# UNITED STATES PATENT AND TRADEMARK OFFICE

APPLICATION NO.	FILING DATE	FIRST NAMED INVENTOR	ATTORNEY DOCKET NO.	CONFIRMATION NO.
10/530,077	09/22/2005	Marcos Giovanni Bortoli	04306/0202707-US0	7459

<b>Office Action Summary</b>	<b>Application No.</b>	<b>Applicant(s)</b>	
	10/530,077	BORTOLI ET AL.	
	<b>Examiner</b>	<b>Art Unit</b>	
	DNYANESH KASTURE	3746

## **DETAILED ACTION**

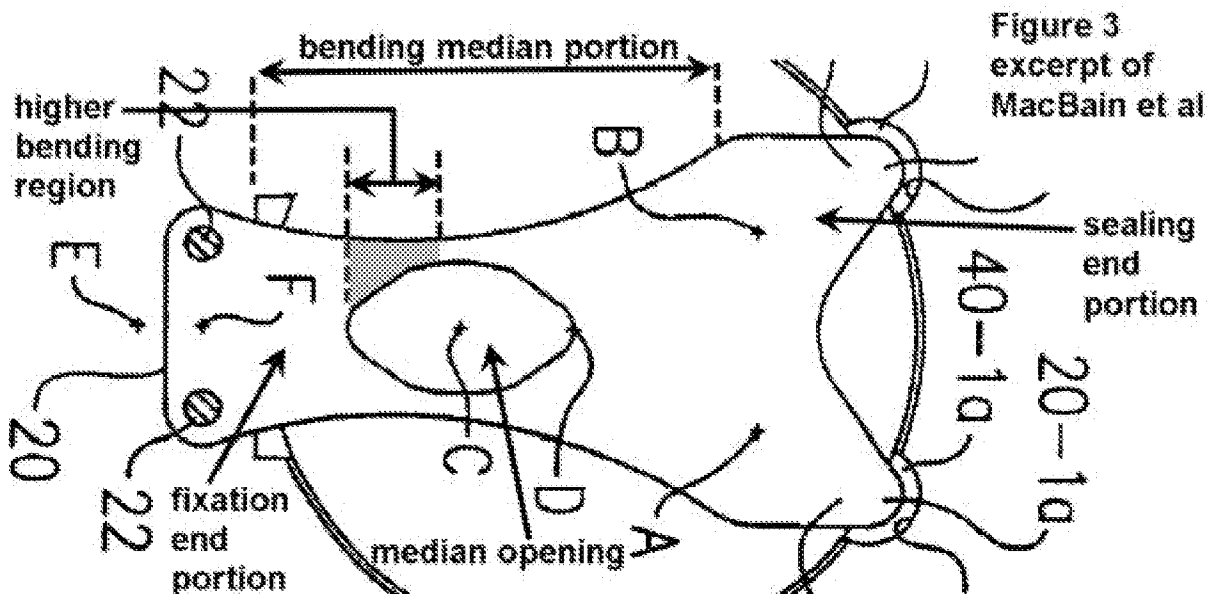
6. In Re Claim 10, the phrase "a substantially semi-elliptical contour with its vertex being tangent with the fixation end portion" is indefinite due to the following: When an element is referred to as being tangential with an object (fixation end portion), the element is usually a curve or a surface or a line; but it never is a POINT - which is what "vertex" is as referred to in the claim. How can a point (vertex) be tangent to anything ? Even if an imaginary line was drawn demarcating the border between the higher bending region and the fixation end portion, it is this line that would be tangential to the semi-elliptical contour (at the vertex). THE POINT OF CONTACT between this line and the contour would be the vertex.

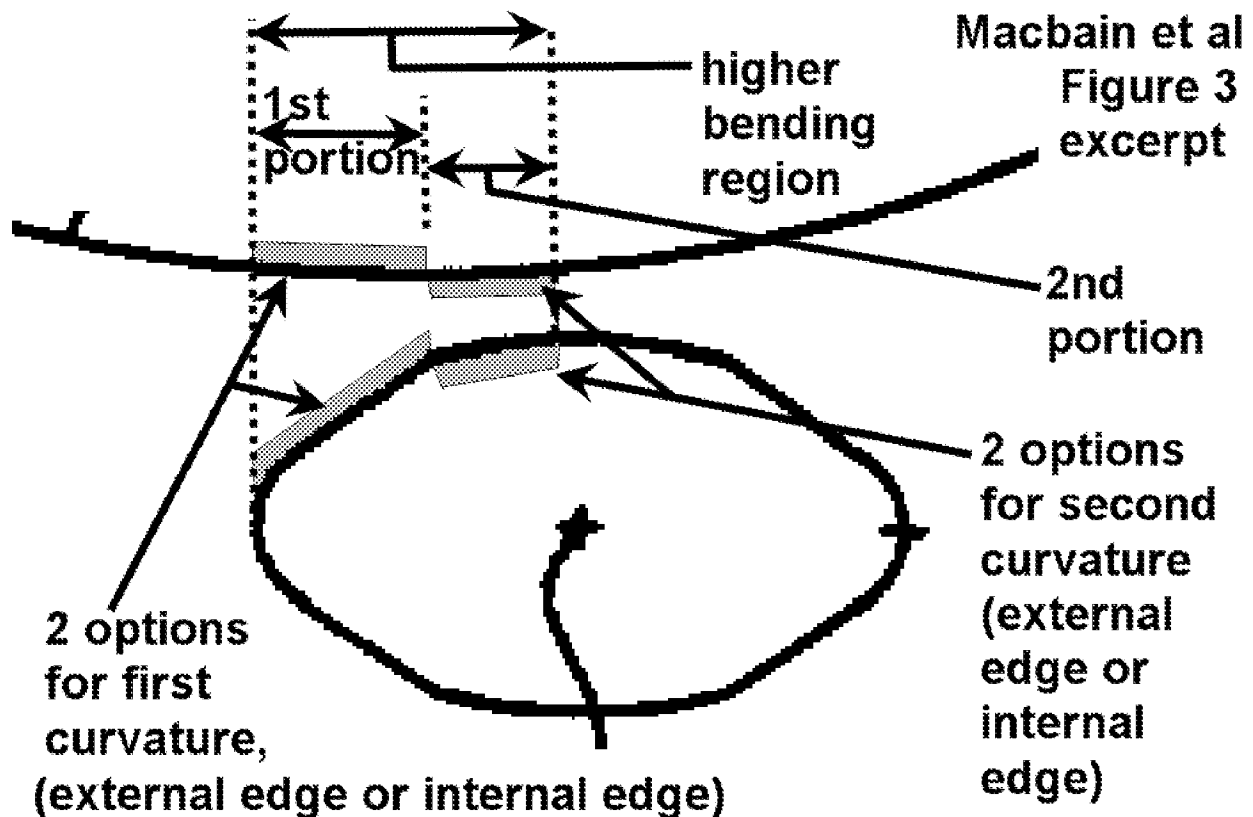
9. In Re Claim 10, with reference to Figure 3 annotated above, MacBain et al discloses a suction valve for a small hermetic compressor (Abstract states “compressor suction valve”) of the type presenting a compression cylinder (D) which has an end closed by valve plate (30), said valve comprising:

- a fixation end portion (annotated) to be affixed to the valve plate;
- a bending median portion (annotated) provided with a median opening (annotated) aligned with a discharge orifice (see Figure 1); and
- a sealing end portion (annotated) operatively associated with the suction orifice provided in the valve plate,

- a higher bending region (as annotated by the shaded area, the width of which decreases along the higher bending region) of the flexible vane of the valve

- a first portion of the higher bending region as depicted above, bounded by at least one curved edge (first curvature) represented by the external edge of the flexible vane; (the shaded rectangles in the annotated first and second portions above highlight the options for the first and second curvatures)

- a second portion of the higher bending region as depicted above, bounded by the curved external edge and curved internal edge (second curvature)
- the claim limitation of the distance between an external edge of the flexible vane and its adjacent internal edge portion of the median opening diminishes more rapidly in a first portion, is anticipated by the steep decline in the first portion when compared to the gradual decline in the second portion; from a maximum value close to the end fixation portion, to a minimum value, close to the boundary of the higher bending region of the flexible vane,

- wherein the flexible vane is configured to distribute opening forces along the higher bending region (no areas of stress concentration) allowing the flexible vane to be bent along the higher bending region in an open position, and

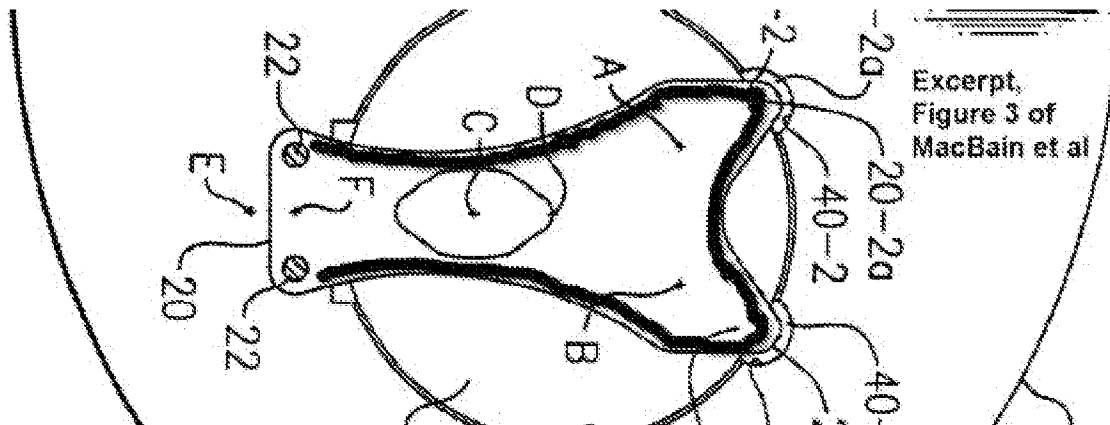
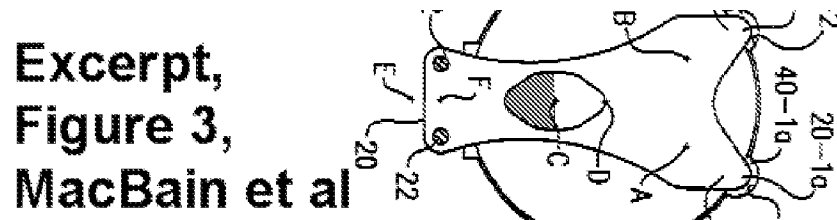
- the bending median portion and sealing end portion “presents” a U shape as annotated below, with the legs being symmetrical about a longitudinal axis of the flexible vane, are of equal length and are united by the fixation end portion as depicted:

(Note that the limitation “presenting” could also be broadly interpreted as enclosing a U shape, since the outline is not being claimed as U shaped. Further, the “united by” limitation could be interpreted as bringing the two legs together.)

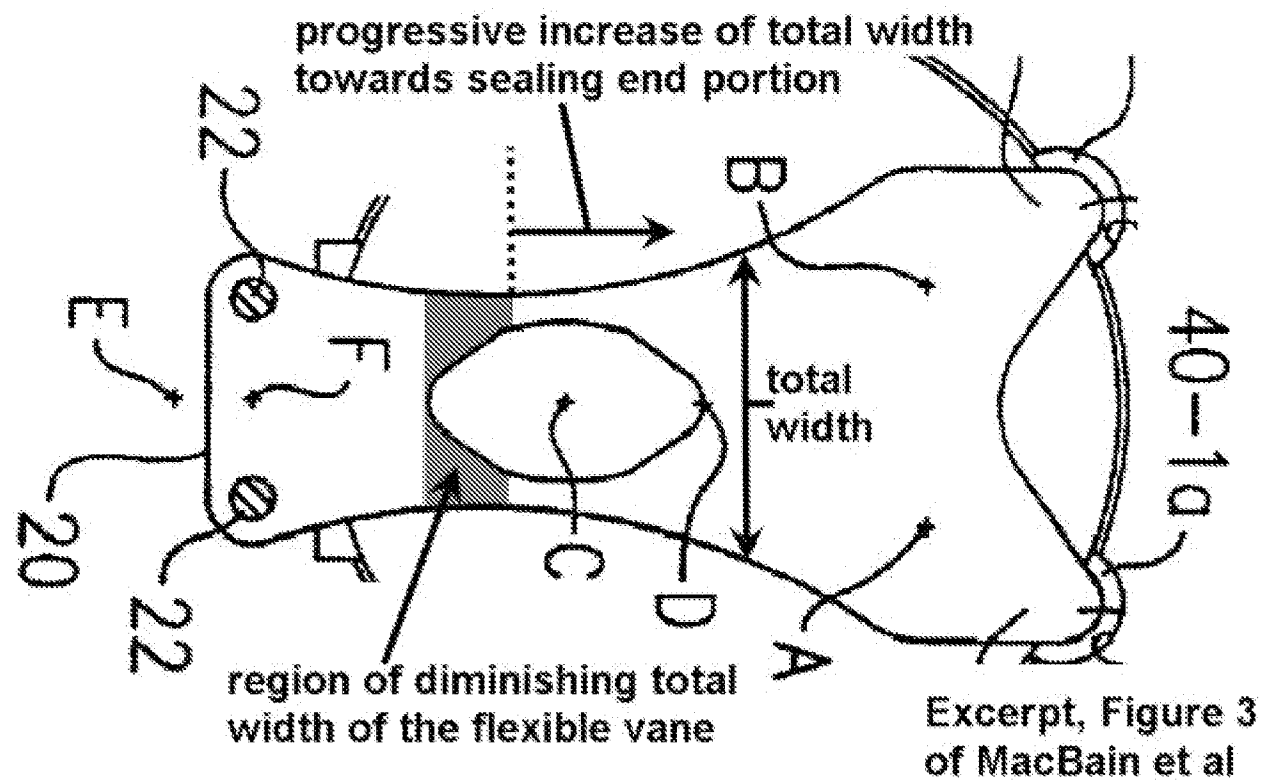
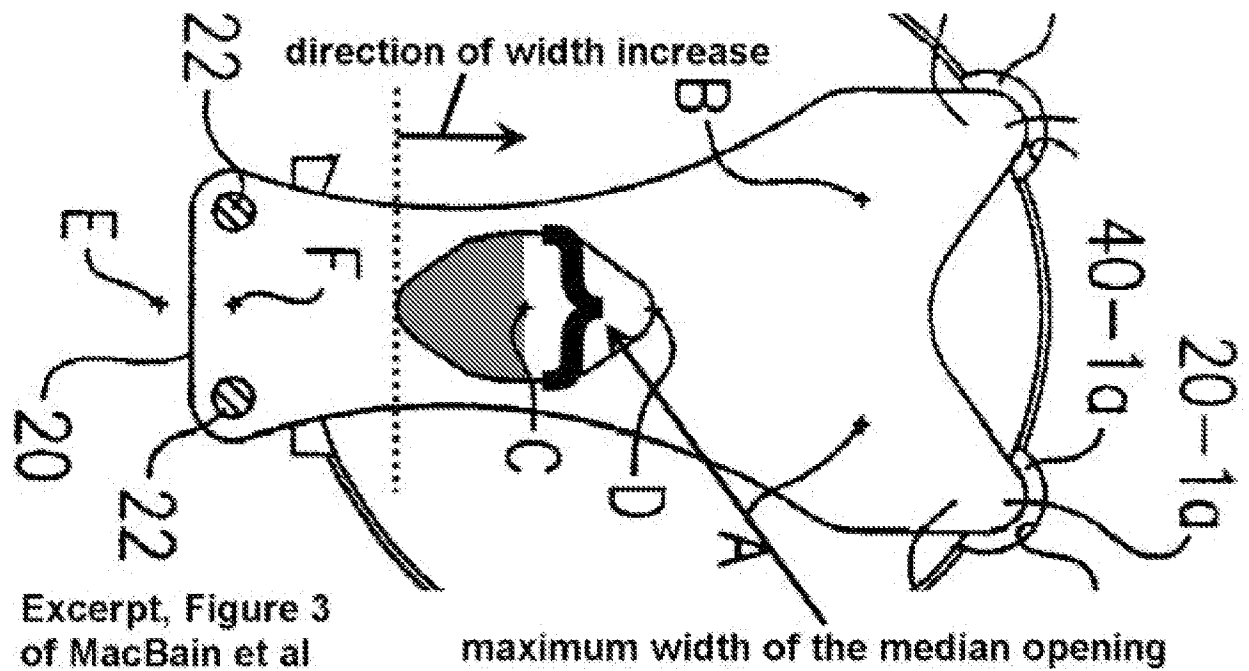
- wherein the median opening of the valve presents, along the higher bending region, a substantially semi-elliptical contour (the curved boundary of the shaded area in the annotated figure above is substantially semi-elliptical), and as best understood, “its vertex being tangent with the fixation end portion “

- wherein the width of the median opening of the flexible vane increases, progressively (see annotations above), from a region adjacent to the fixation end portion (22) to at least the opposite boundary of the higher bending region, whereas the total width of the flexible vane diminishes from the fixation end portion, at an initial portion (see shaded area and annotations above), and then it begins to progressively increase as depicted towards the sealing end portion, from before the opposite boundary of the higher bending portion

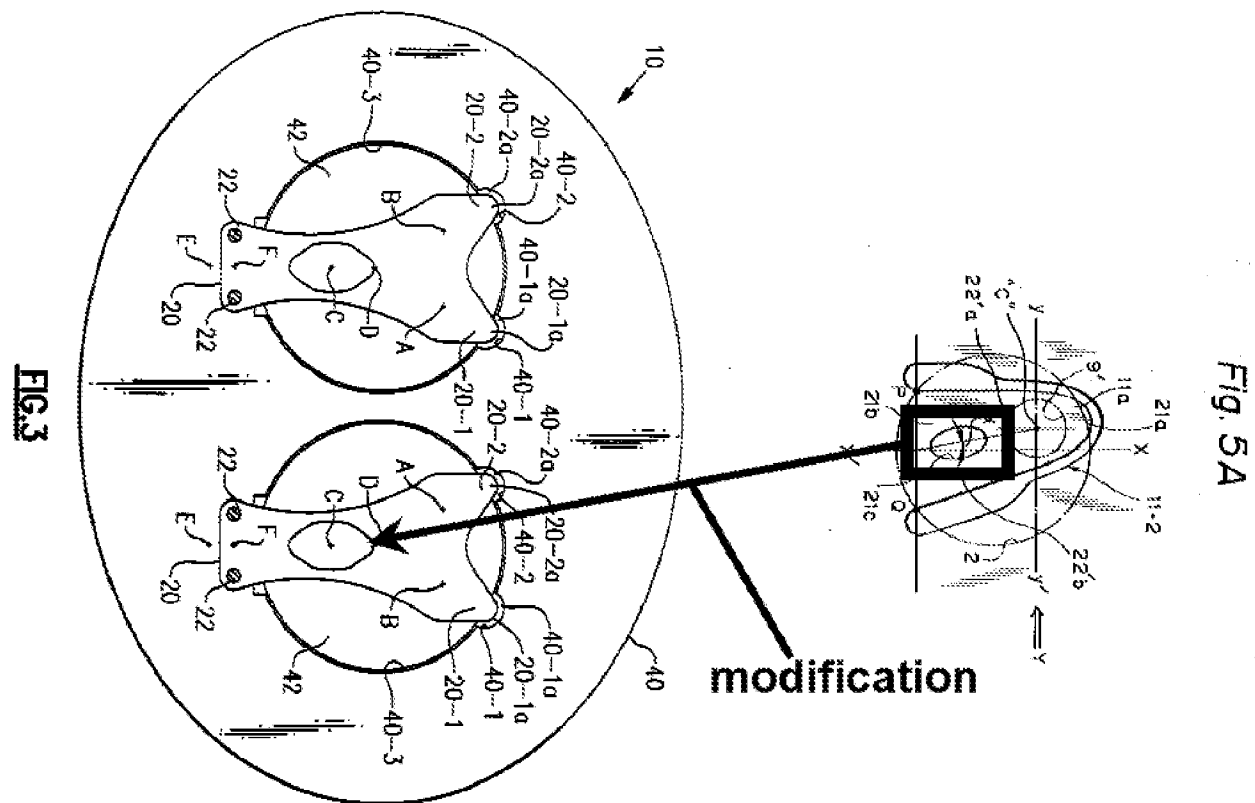
16. Alternatively, Claim 10 and Claim 8 are rejected under 35 U.S.C. 103(a) as being unpatentable over MacBain et al (PG Pub US 20030068245 A1, filing date: October 5, 2001) in view of Ikeda et al (US Patent 4,764,091 A)

(elliptically shaped opening) of Ikeda et al because the modification yields predictable results (MPEP 2141, Section III, Rationale B: "Simple substitution of one known element for another to obtain predictable results") since both valves relate to the suction side of reciprocating piston compressors.

21. Nevertheless, Ikeda et al discloses a gap that is larger at the fixed end of the vane than its apex.
